147 Major St — HVAC clash mark-up

HVAC Designs LO# 113963 (HVA 26 167838) vs permit 26 167838 BLD 00 · PalmView BIM review · Oct 22, 2026

Two systems: F-1 basement (basement + main floor from below) · F-2 2nd-floor mech room (2nd + 3rd floors from the 3rd-floor joist space).

Sheet Title
BASEMENT HEATING LAYOUT

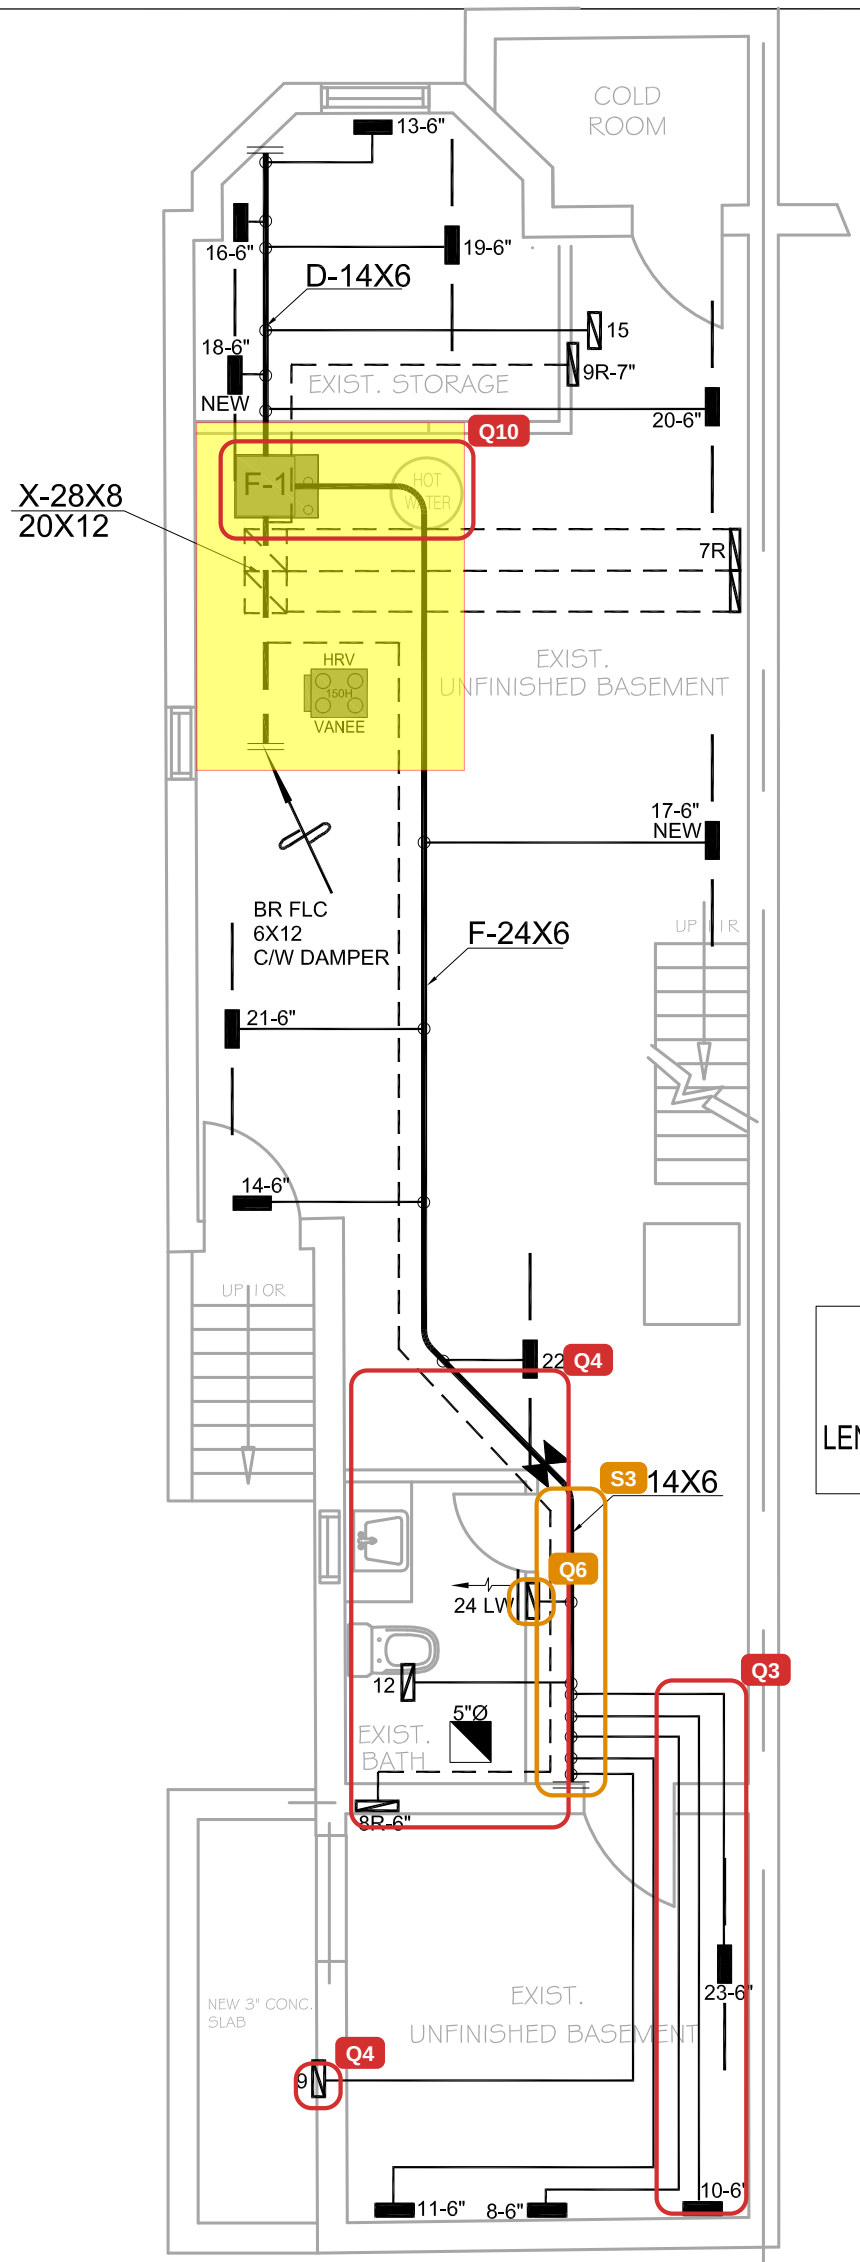
Core three holes in the brick, or route all rear branches through the existing 30" opening. Owner: HVAC sub. Status: OPEN.

Both stacks land on top of existing masonry (powder E wall, pantry/storage double wall). Relocate. Owner: HVAC Designs. Status: OPEN.

F-1 not tagged existing and sits where the permit shows the existing H.E. furnace. Takeoff runs over the tank vent. Owner: PalmView. Status: OPEN.

Q3 Rear branches 8, 10, 23 through the old rear foundation

Q4 Supply 9 and return 8R sit on old foundation walls

Q6 7" return stacks in 2x4 walls (1R–6R, 9R) and 6" supply stacks

Q10 F-1 new or existing; hot water tank vs plenum

S3 Trunk E ends ½" off the old rear wall

Sheet Title
FIRST FLOOR HEATING LAYOUT

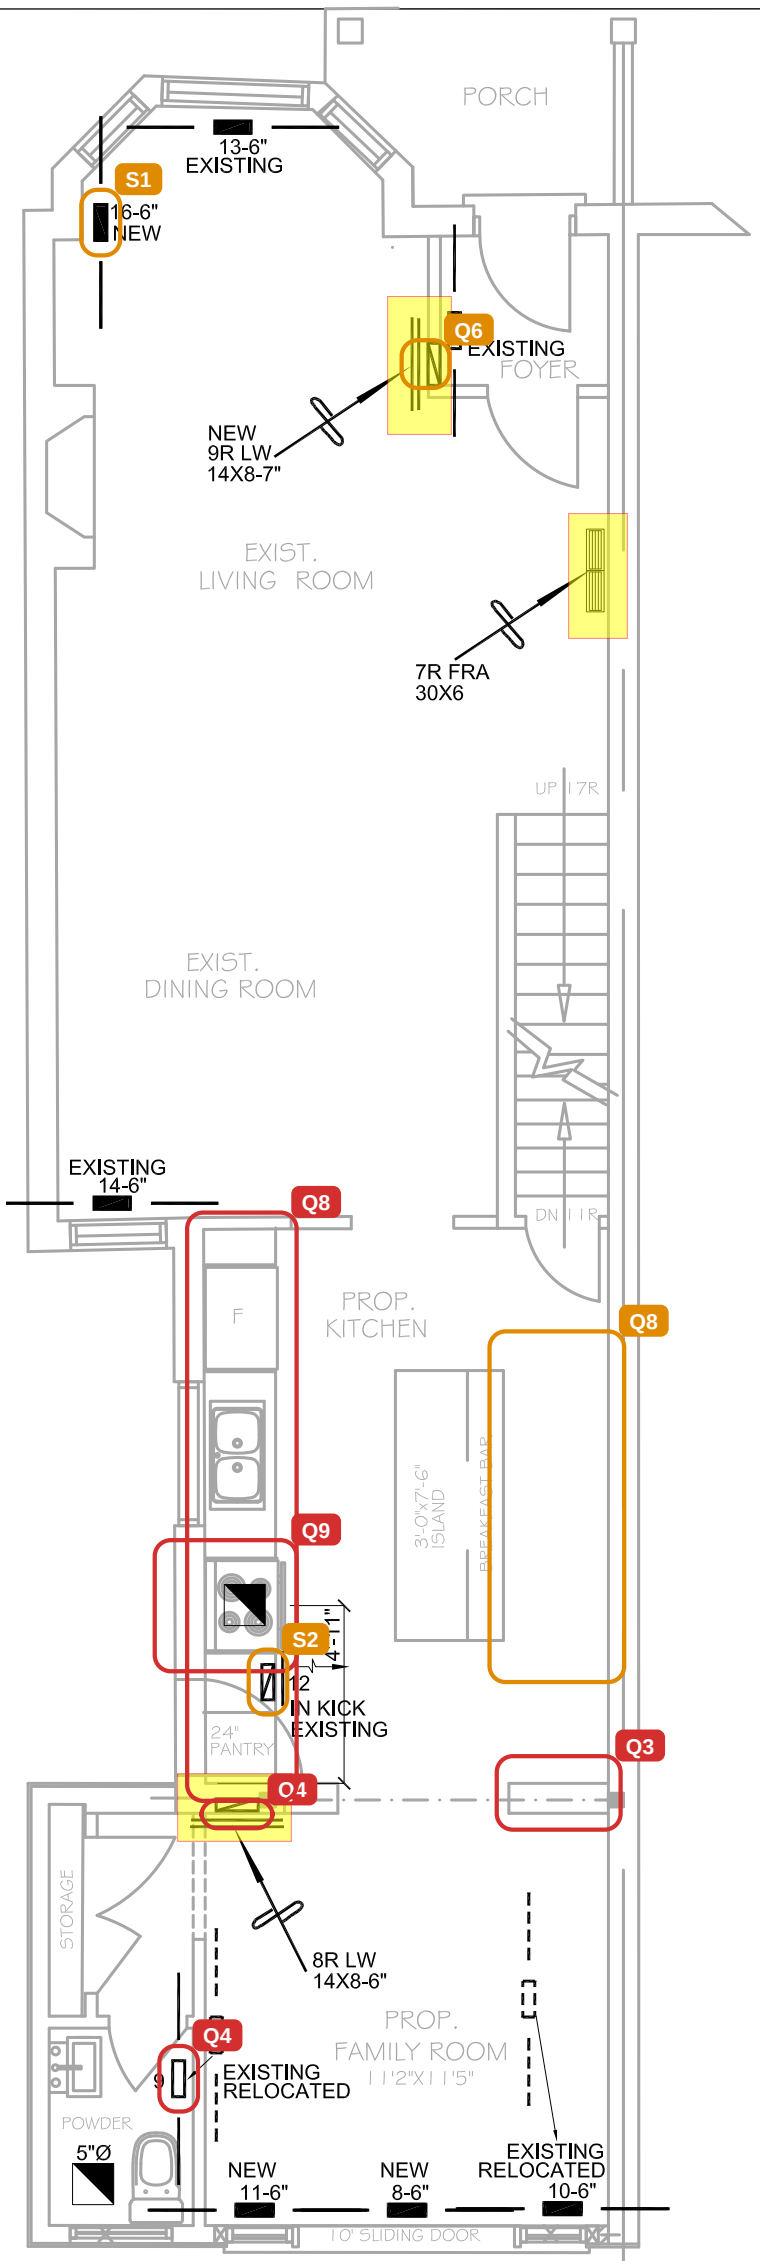
Permit shows a 30" range and 34" fridge; Miele range and fridge are 36". Cabinet set 186.5" vs 184.6" wall. Aisle to the stair is 34.9". Owner: Cabinet shop / PalmView. Status: OPEN.

Elica Trento insert on the south wing wall under the 2nd-floor overhang. No duct or termination drawn. Owner: HVAC Designs. Status: OPEN.

- Q3 Rear branches 8, 10, 23 through the old rear foundation
- Q4 Supply 9 and return 8R sit on old foundation walls
- Q6 7" return stacks in 2x4 walls (1R–6R, 9R) and 6" supply stacks
- Q8 Kitchen sizes: range, fridge, run length and aisle
- Q9 Kitchen hood exhaust not designed
- S1 Supply 16 boot tight to the bay corner
- S2 Supply 12 kick register under the pantry

Sheet Title
SECOND FLOOR HEATING LAYOUT

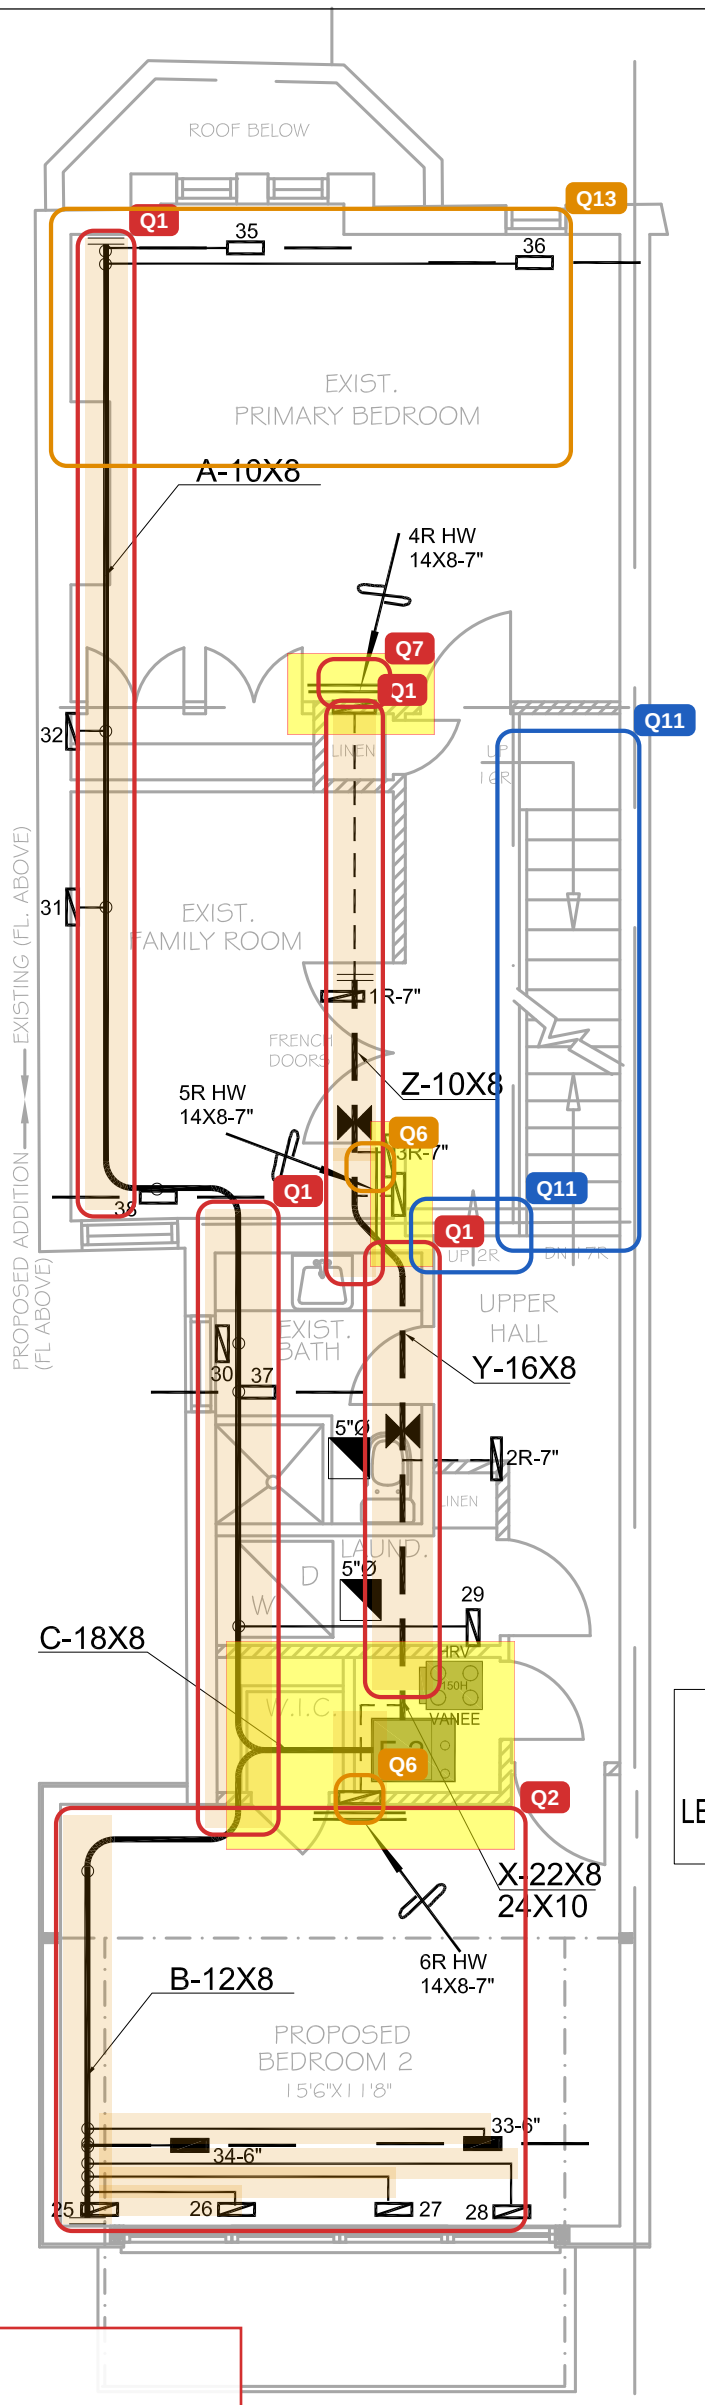
Rear (lower) level, 10'-4½" ceiling: drop the hall / bath / laundry / W.I.C. / bedroom 2 ceilings flat to ~9'-6" to hide C, B, Y, 6R and branches 25-28, 33/34 (or box them at 9'-8"). Front (upper) level, 9'-0½" ceiling: trunk A along the south wall and return Z in the family room need 14" bulkheads at 8'-4", or a reroute. Owner: PalmView / client. Status: OPEN.

Confirm the cantilever TJIs over bedroom 2 run front-to-back (balcony). Trunk B sits on the south LVL1; 5 branches cross 26 cantilever joists. Owner: Kott / Rona + engineer. Status: OPEN.

Grille is on the closet wall right under LVL5; the stack cannot pass the beam. Owner: HVAC Designs / engineer. Status: OPEN.

Plans A8/A9: new stair stacked over the existing one, rising front-to-rear. Section A-A draws it rising rear-to-front. Step: section A-A framing shows 16" (2R at 8"); the rear and south elevations show 1'-9" (10'-11" vs 9'-2"). Model uses 16". Owner: PalmView / designer. Status: OPEN.

Trunk A (first 6.7 ft) and branches 35/36 are under the existing front roof. If that space is outside the insulation, ducts need R-12 + Class A sealing (permit note). Owner: PalmView. Status: OPEN.

Q1 2nd-floor ceilings for the F-2 trunks

Q2 Bedroom 2 ceiling: joist direction and trunk B on LVL1

Q6 7" return stacks in 2x4 walls (1R–6R, 9R) and 6" supply stacks

Q7 Return 4R stack vs the LVL5 flush beam

Q11 Stair direction 2nd → 3rd, and the size of the 2nd-floor step

Q13 Front roof space over the primary bedroom

Front (existing house, y < 28 ft) is the upper level at 113.85; the kitchen-wing / addition part steps down. Measured 16" from the section A-A framing; UP 2R at the stair landing; flush LVL5 on the step line. Ground stair 17R lands on the lower level. Model updated.

Sheet Title
THIRD FLOOR HEATING LAYOUT

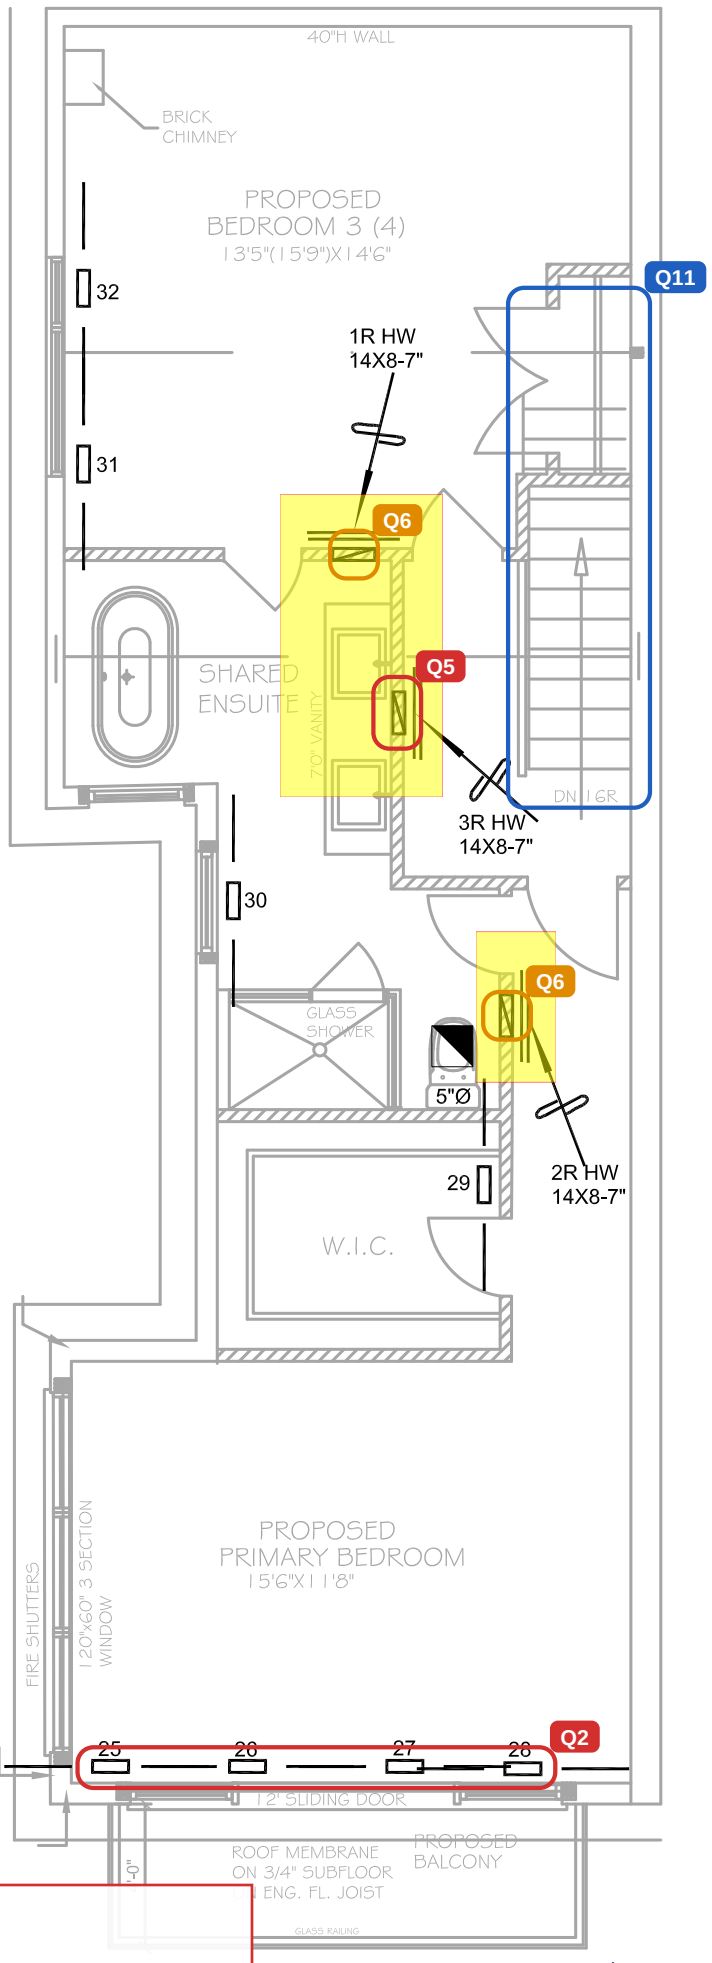
High-wall grille + 7" stack behind the 72" vanity, mirrors, sconces and feature tile. Owner: HVAC Designs / designer. Status: OPEN.

Q2 Bedroom 2 ceiling: joist direction and trunk B on LVL1

Q5 Return 3R on the ensuite vanity / mirror wall

Q6 7" return stacks in 2x4 walls (1R–6R, 9R) and 6" supply stacks

Q11 Stair direction 2nd → 3rd, and the size of the 2nd-floor step
